**Former Gas Plant Remediation and Depot Park Project  
Profession Services Contract Amendment # 14**

**Task 5.2.5 – Depot Avenue Segment 3 Reconstruction  
SCOPE OF SERVICES**

**PROJECT: DEPOT AVENUE SEGMENT 3 RECONSTRUCTION**

FIGURE 1.  
LOCATION OF ARSENIC REMEDIATION (TASK 8.3)

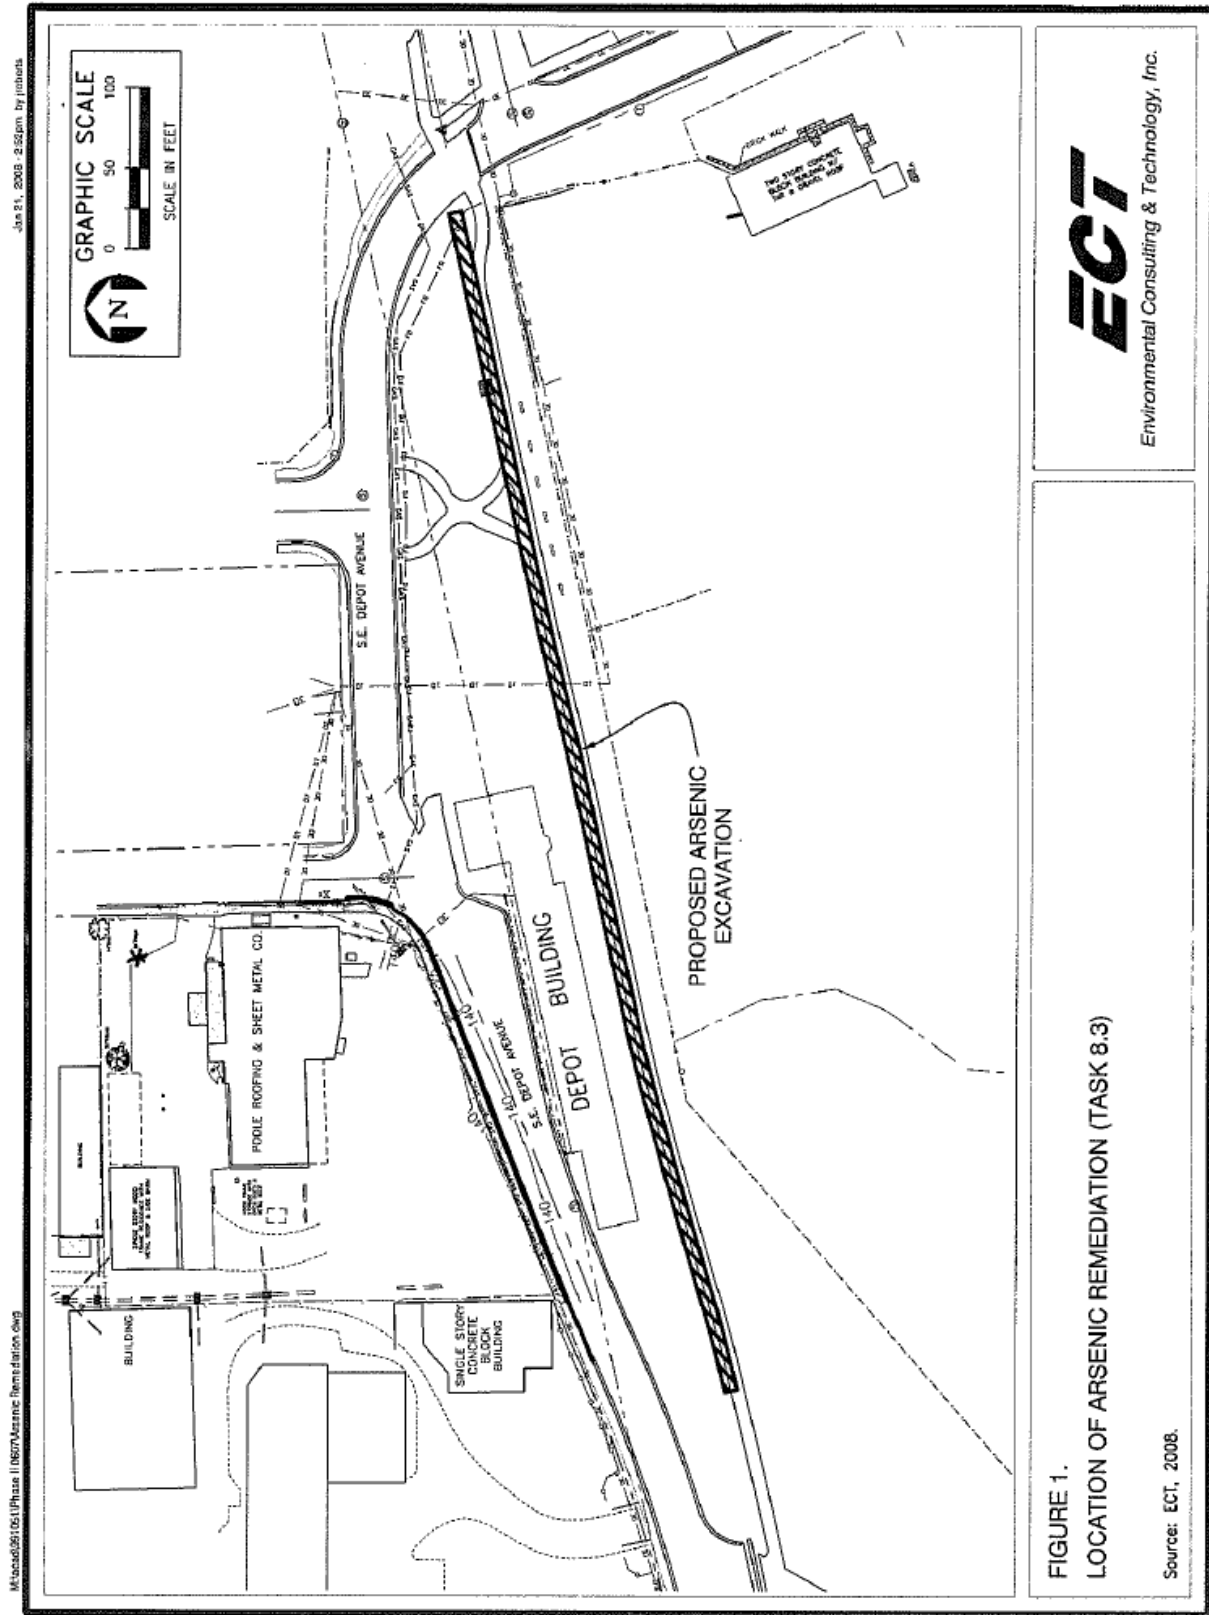
This proposed new task includes the costs to prepare bid documents, provide contract procurement assistance, provide field oversight (including sampling and analysis), and prepare a source removal report for the remediation of the non-coal tar related arsenic contamination along the bike path behind the Depot Building (see attached Figure 1 for location). The remediation fieldwork will be done following approval of the CSX URAP

and prior to or during the Poole Roofing excavation. The general scope of work is to excavate an 8-ft wide by 2-ft deep by 850-ft long strip of arsenic contaminated soil (approximately 750 tons) along the bike path and dispose of the soil at Waste Management's Chesser Island, Georgia landfill. Confirmatory samples will be collected at 20-ft intervals along the walls of the excavation (88 total) and additional excavation and re-sampling conducted as needed. A contingency for an additional 750 tons of contaminated soil and an additional 60 confirmatory samples will be assumed. The City will procure the remediation contractor separately.
